**The Tunnel Water Company
P.O. Box 2017
Fort Collins, CO 80522-2017**

Re: CWCB CONTRACT: Loan/Private CMS: 83655/CORE: CT2016-2001

**LARAMIE TUNNEL EAST PORTAL
OUTLET STRUCTURE REHABILITATION**
PREPARED FOR
WATER SUPPLY AND STORAGE COMPANY
PREPARED BY

Re': Laramie River Tunnel – East Portal

TITLE
REMOVABLE WALL SECTION DETAILS

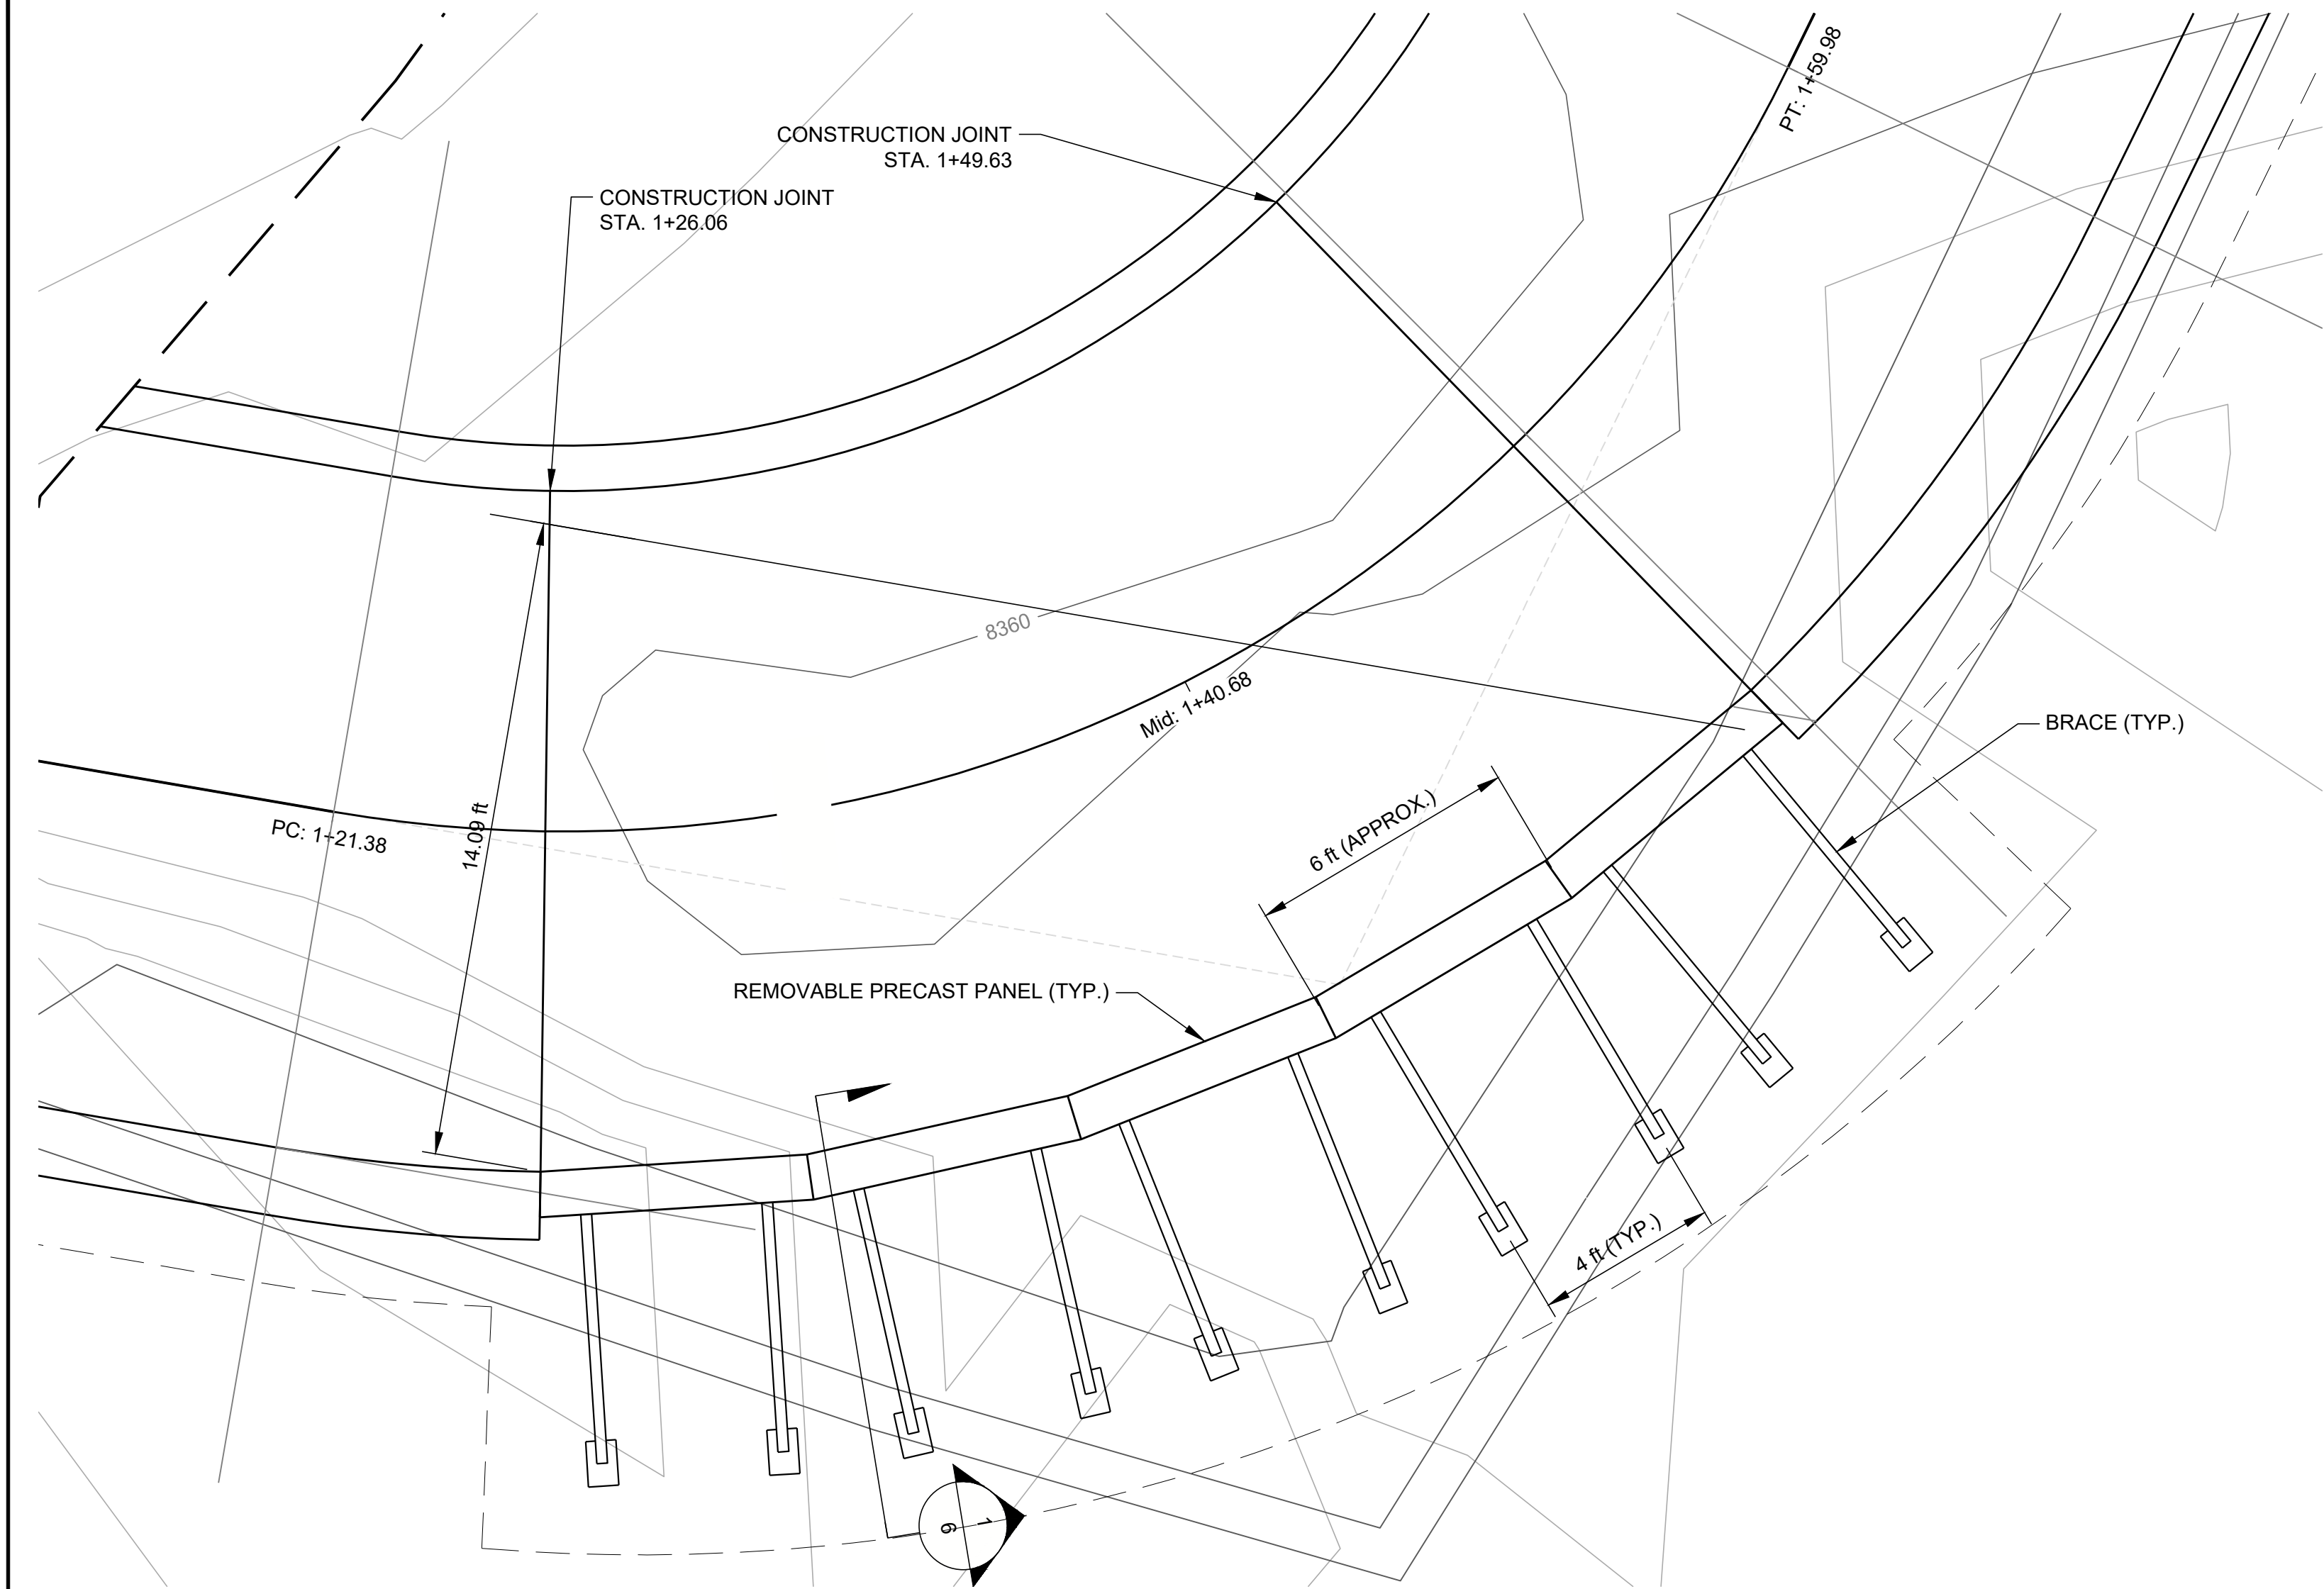
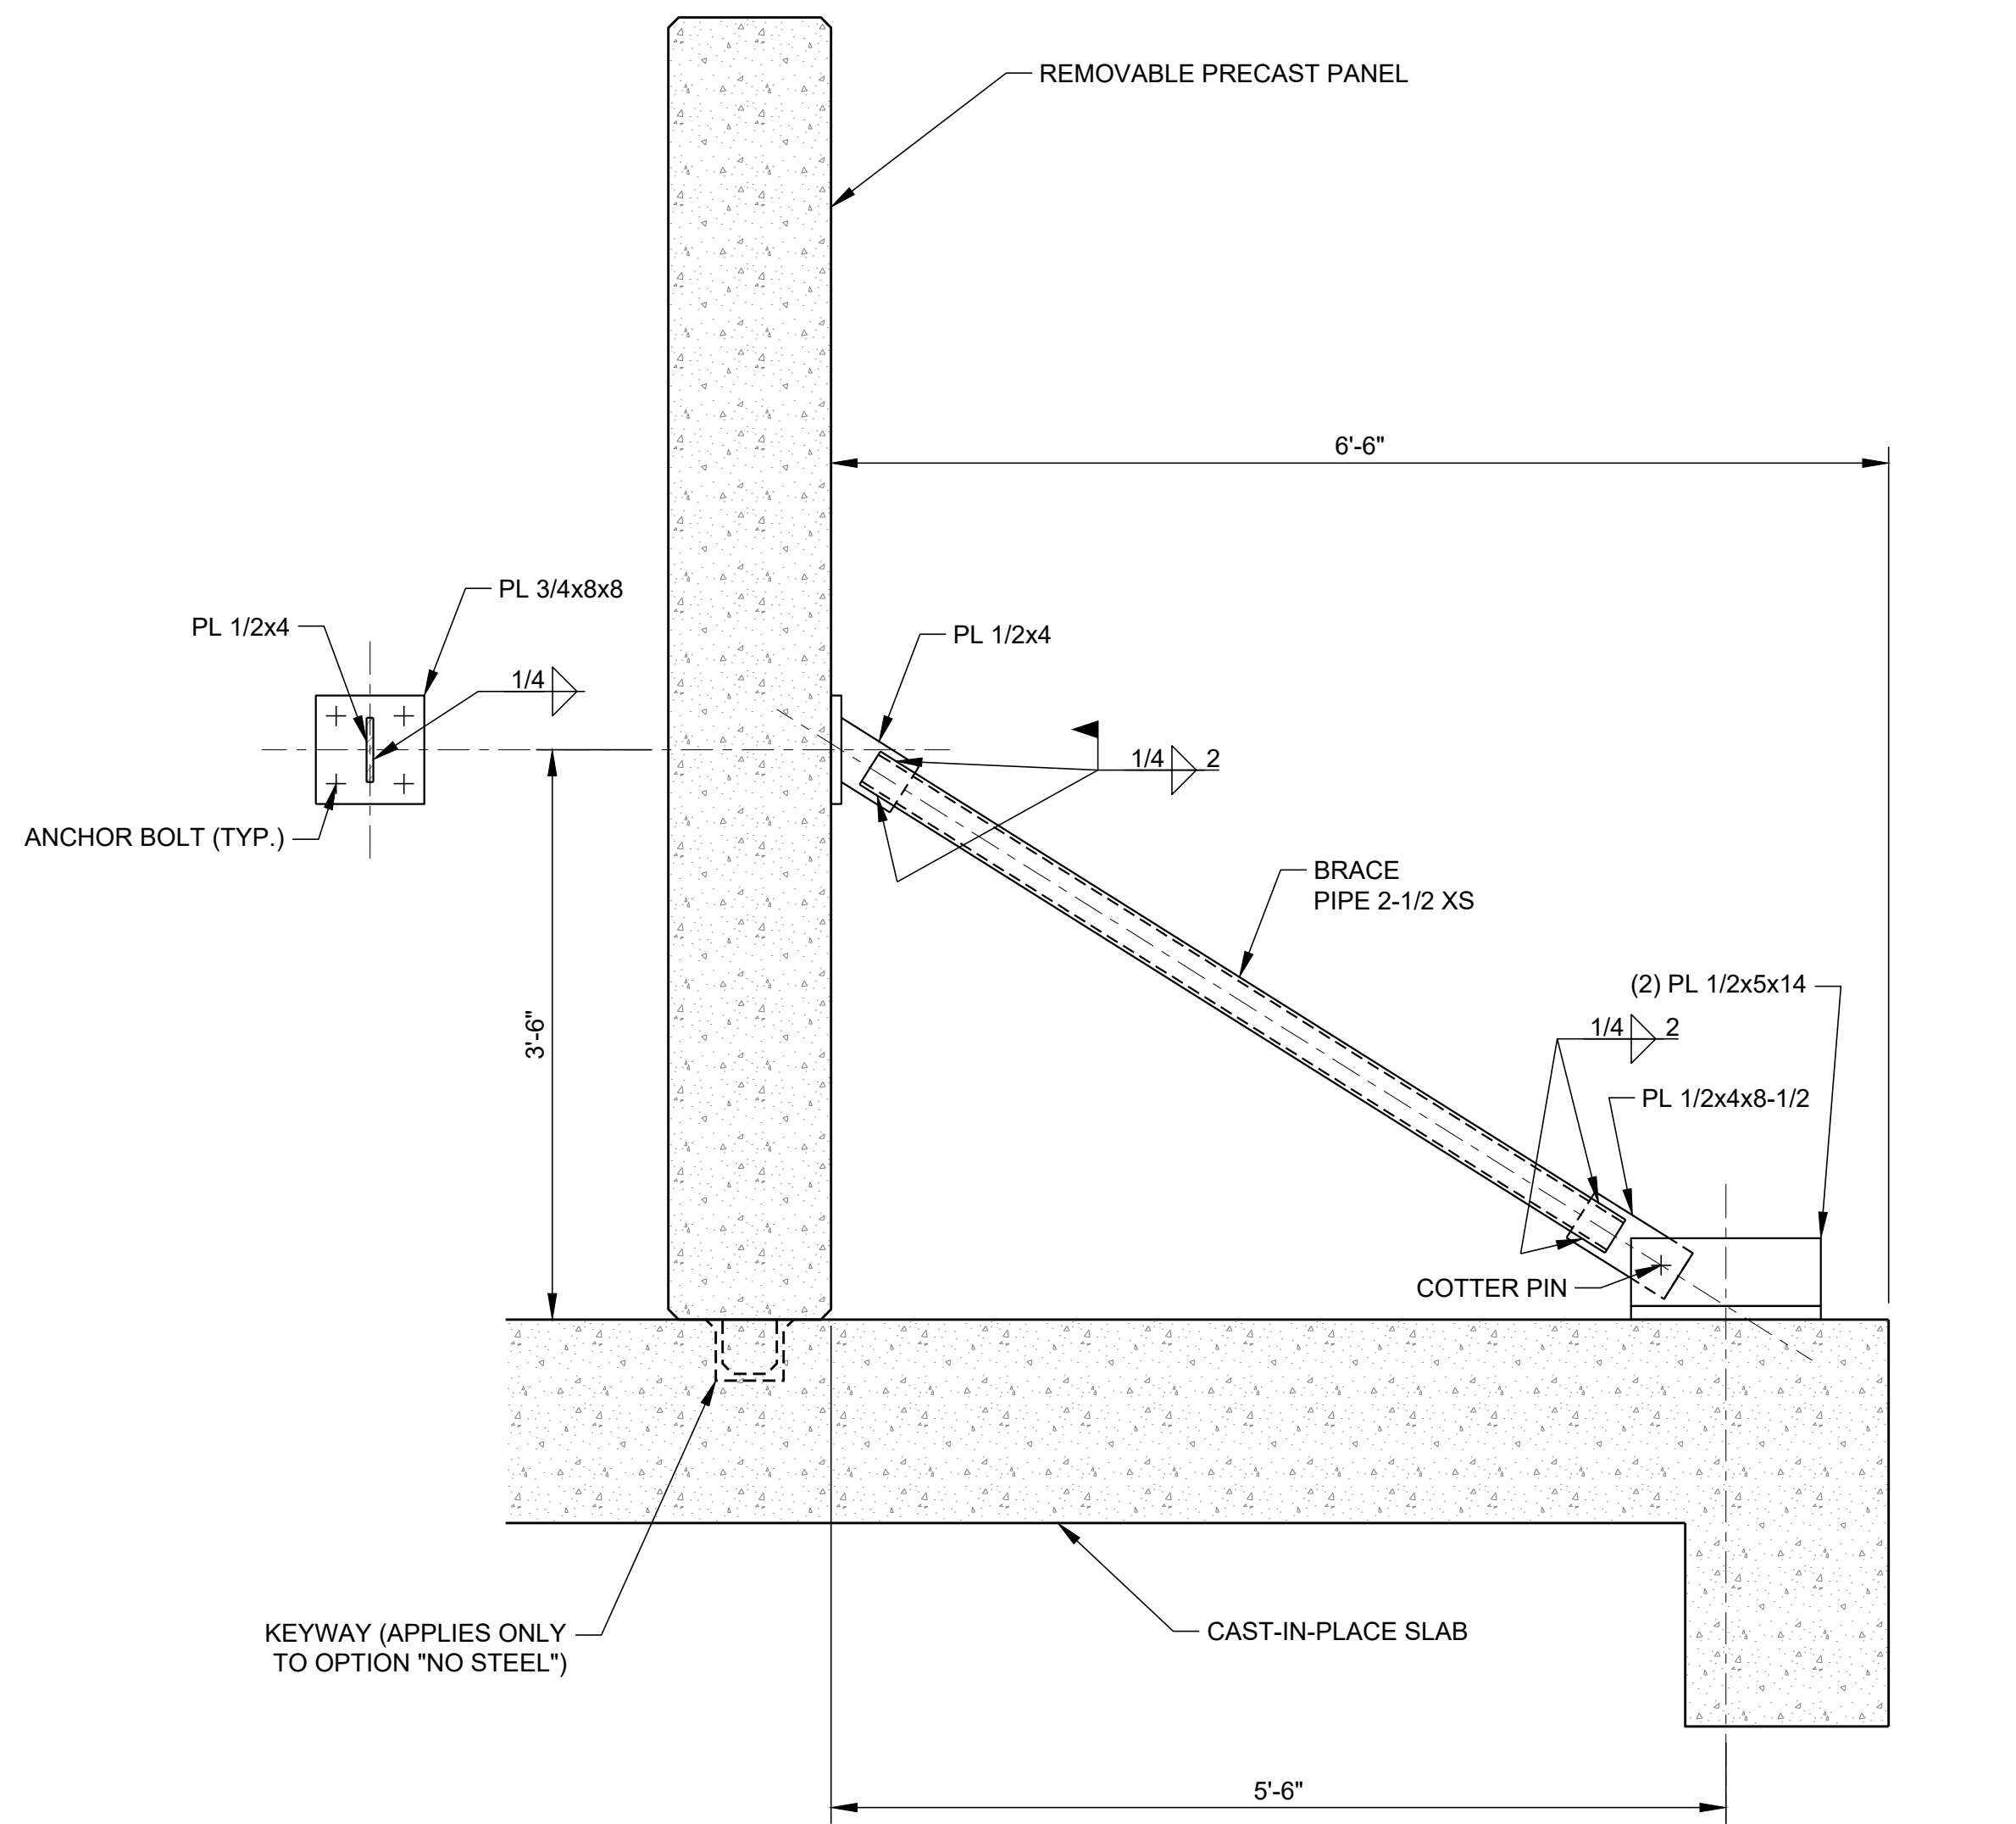
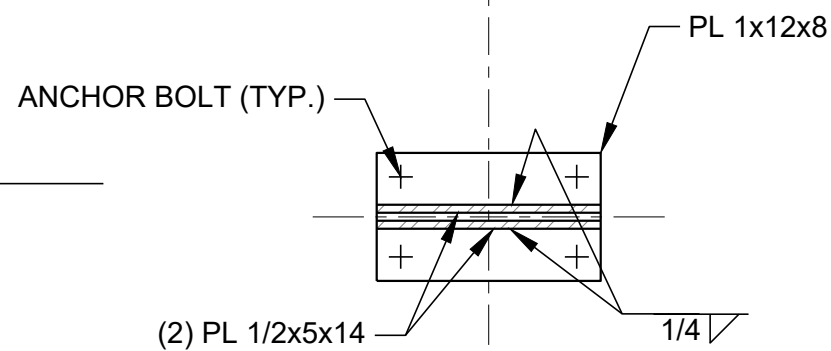
Following completion of the Laramie River Tunnel-West Portal in 2016, Golder Associates and I prepared a conceptual plan for the rehabilitation of the East Portal. The Portal has had extensive repair work done to it over the last 75+ years and is in need of total reconstruction. The work involves the total removal of the existing outlet portal, reconstruction of the outlet channel, a new connection to the outlet cut-off wall at the existing creek, and reclamation of the site and any disturbed lay-down areas. The proposed plans for this work as prepared by Golder on the 29th of September 2016 are attached. (Please note that following our discussions last year, the maintenance access wall on drawing No.6 has been removed and replaced with a poured-in-place semi-circular wall.)
